# Technical Service Bulletin

Car #: D71-21-2

Standard  
Transmission  
Synchro-  
nizer  
Rings

MODELS: All  
Models Equipped  
With an A-230  
or A-833  
Transmission

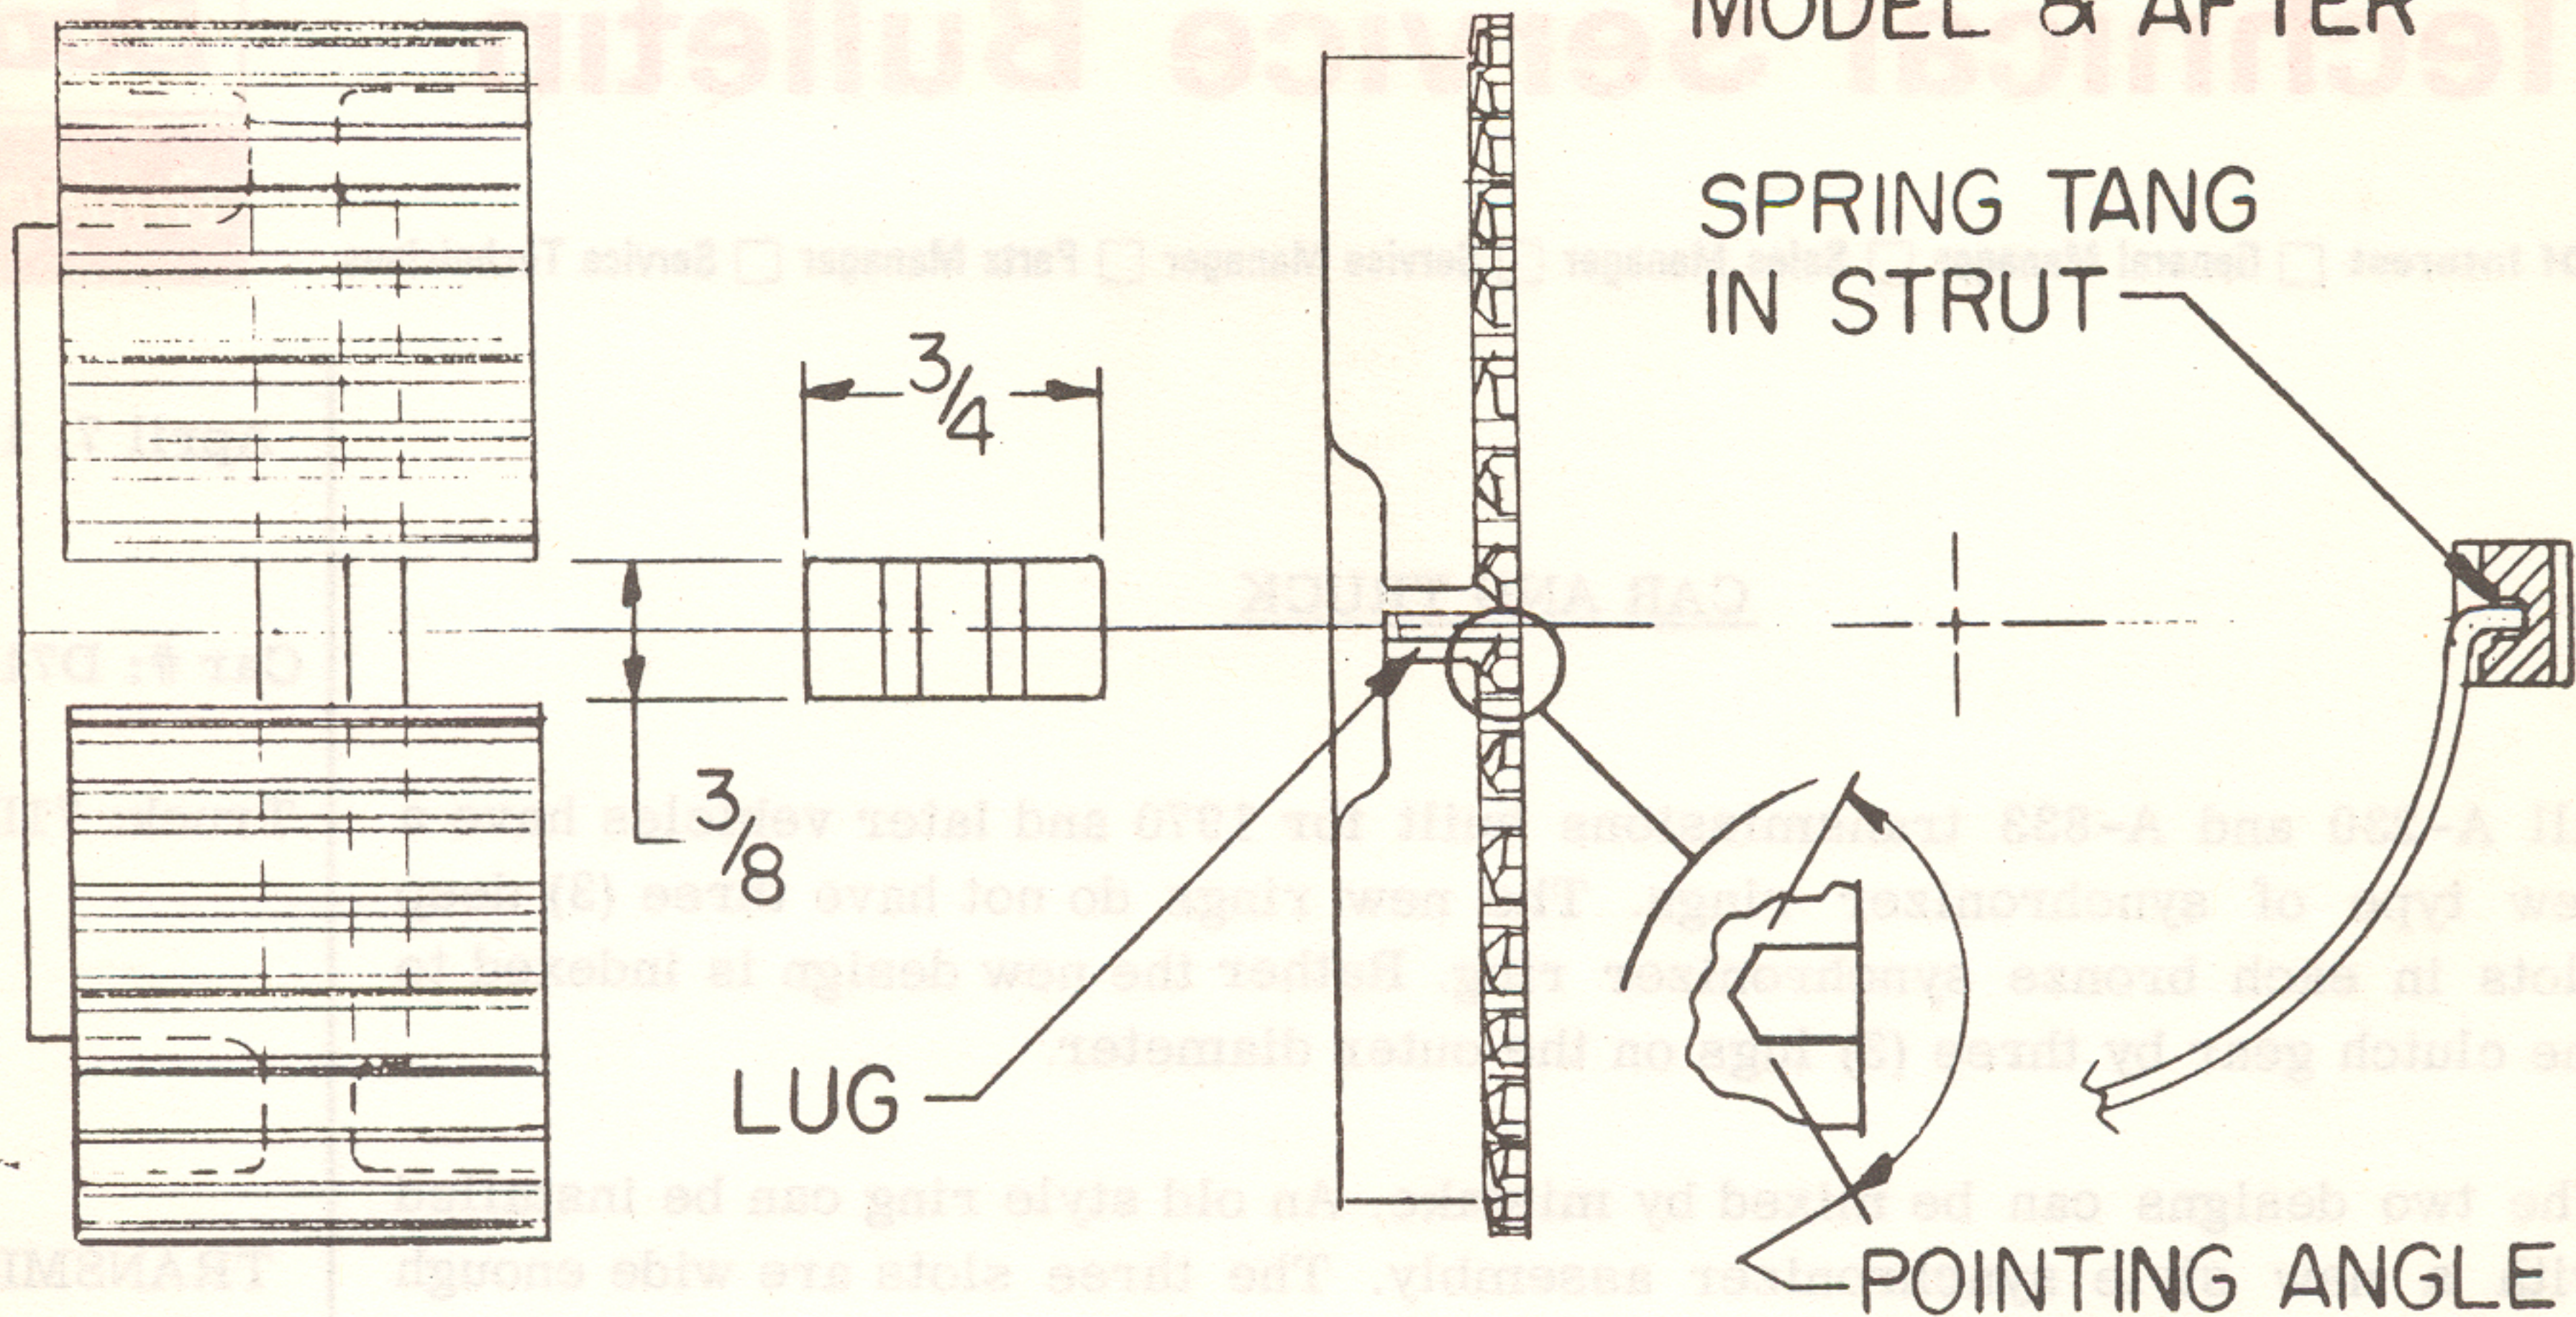
All A-230 and A-833 transmissions built for 1970 and later vehicles have a new type of synchronizer rings. The new rings do not have three (3) deep slots in each bronze synchronizer ring. Rather the new design is indexed to the clutch gear by three (3) lugs on the outer diameter.

The two designs can be mixed by mistake. An old style ring can be installed with a new style synchronizer assembly. The three slots are wide enough to fit over the new wider, shorter struts. This mix results in a definite failure.

The sketch on page 2 shows the basic difference between the two designs. Also shown are the part numbers for the new synchronizer assemblies and bronze synchronizer rings. The new design synchronizer assemblies can be used in all model 833 transmissions back to the original assemblies in 1964 cars.

NEW

230 TRANSMISSION - ALL  
833 TRANSMISSION - 1970  
MODEL & AFTER

OLD

833 TRANSMISSIONS - 1969  
MODELS & OLDER
